Massachusetts Institute of Technology C.S. Draper Laboratory Cambridge, Massachusetts

LUMINARY Memo #167 Revision 1

Subject: Luminary 1D: Which One, What Kind, How Many?

Luminary 1D will be released for the third time on 19 September 1970; its revision # is 178. The new changes incorporated are PCRs 322, 1056 and 1058. Herewith are the descriptions.

R10 COMPUTATIONS in SERVICER

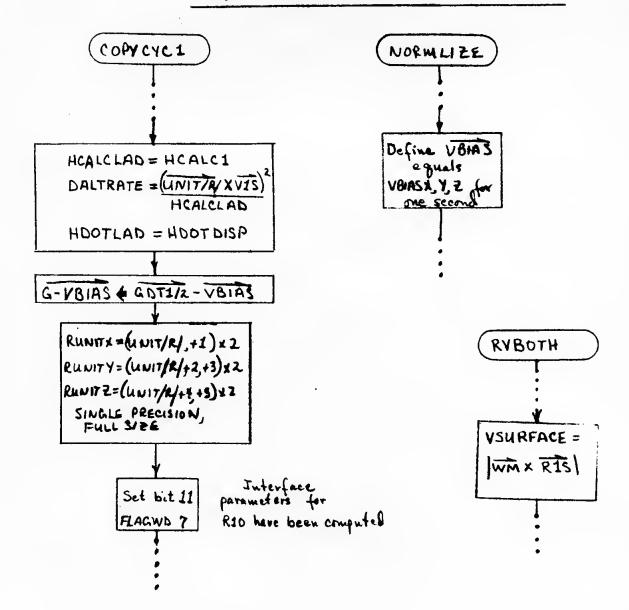
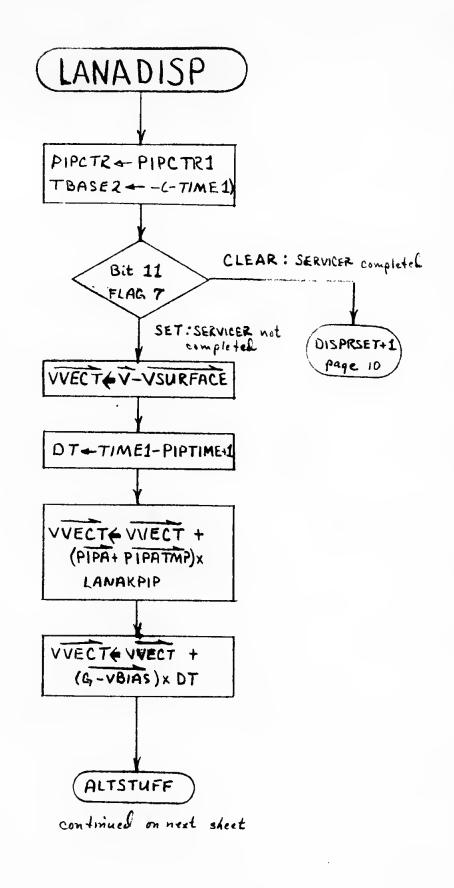
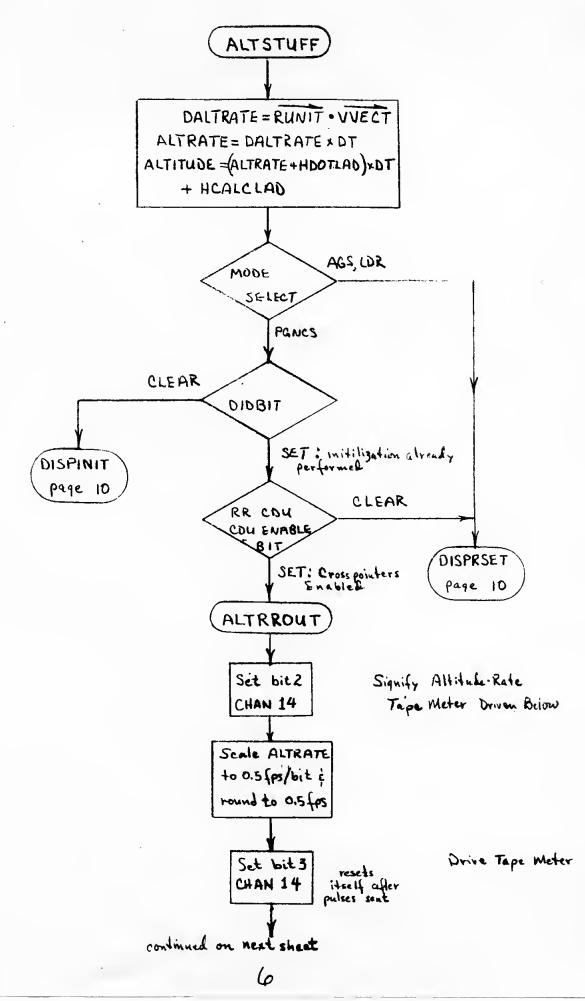
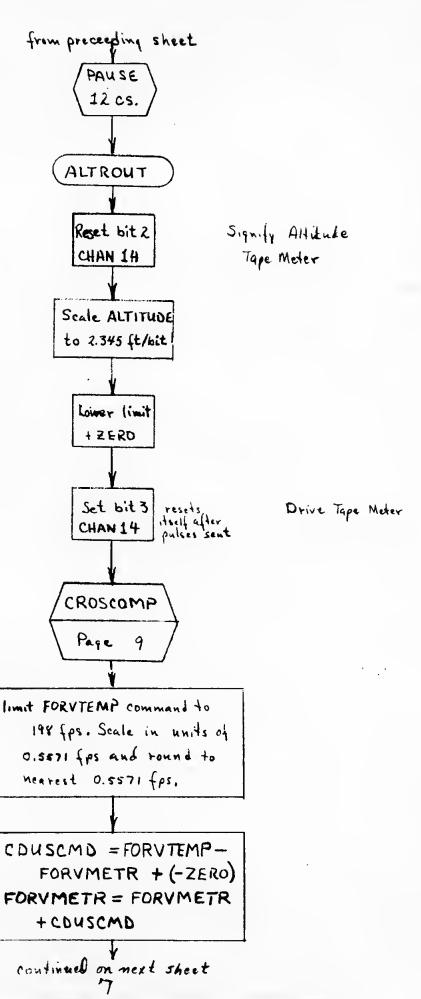
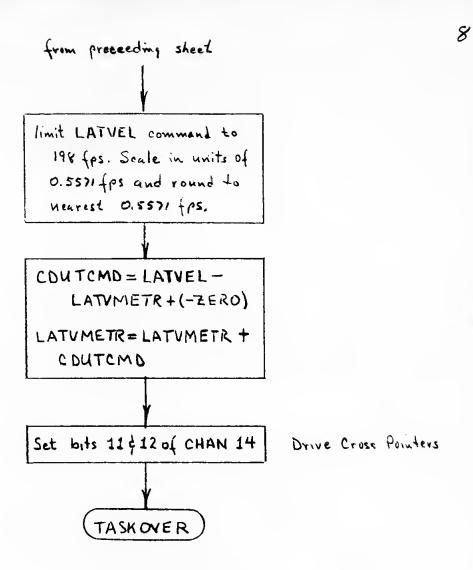
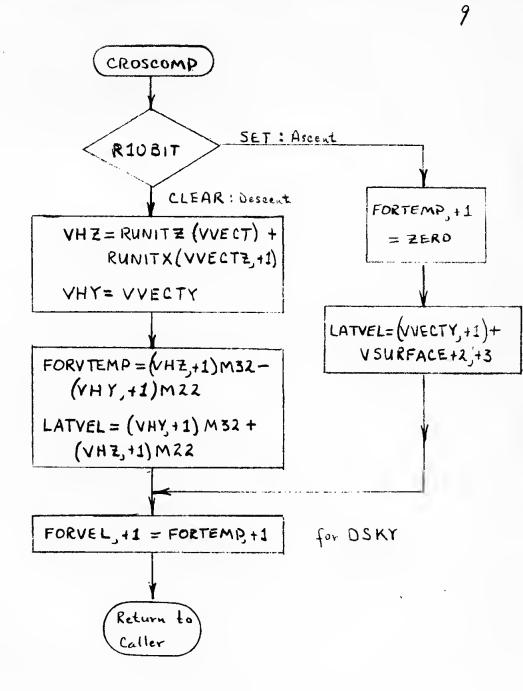
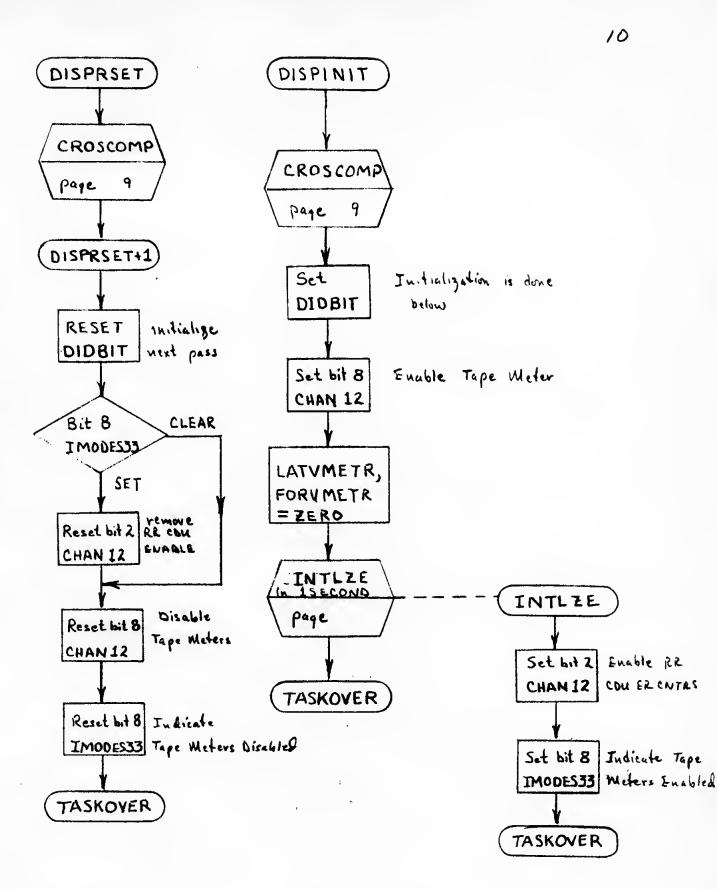
PCR 1058: When it was found that the Landing Analog Displays Routine (R10) gave results with errors up to 3.5 fps in the cross pointer display, a new R10 was suggested to effectively eliminate these errors. In the process the altitude-rate glitch was eliminated. The word saving was 119 words; the new R10 takes 1% longer. The main cause of the errors was the single precision dot products; these were changed to double precision. Also, some computational simplifications were made to the dot products, knowing that the IMU is aligned to the landing site. A PIPA bias correction term is added to increase accuracy; computation of VBIAS formerly done in P66 now done in SERVICER. Altitude is based on a simpler extrapolation \mathbf{is} than before. R10 now computes altitude and Alt-Rate every pass (every 1/4 second) outputting Alt-Rate before a 12 cs pause, Altitude immediately after the pause. Flag bit SWANDISP is now set immediately after SERVICER computes the parameters necessary for R10 so that R10 may start near TIG -30 rather than at ignition. The DIDFLAG definition remains the same; just DID the initialization. IMODES33 bit 7 is no longer used. ACB L-11 and Anomaly L-1B-04 were not incorporated into the new R10 as originally conceived, but they are in Luminary 178: The forward velocity for NOUN 60 will be computed if the MODE SELECT switch is not in PGNCS (and incidentally accurate to 0.1 fps); R10 will be initialized if the RR CDU ENABLE bit is removed by e.g. moving the RR MODE switch into and out of LGC.

The R10FLAG has been redefined. When it's set by P12, P70, P71, the inertial Y velocity will be displayed on the lateral velocity cross pointer while the forward velocity crosspointer is set to be zero.

Flow Charts for R10 and its interface parameter computation are attached. For more details see Luminary Memo #162 by Don Eyles. This memo superceeds Memo #162 where differences occur. Changes to other areas due to R10 design:

1. downlist mnemonids changes

LATVEL to LATVMETR FORVEL to FORVMETR

- 2. VBIAS calculation moved from STRTP66A into NORMLZE;
- 3. For erasable overlay purposes ZAXIS computation moved to Ascent Guidance from P12 initialization.
- 4. The erasable ACSAVE, used in ascent, was moved to avoid conflict with the new configuration of R10 erasables.
- 5. New scaling was implemented to accommodate the double precision value used in R1 of Noun 60.
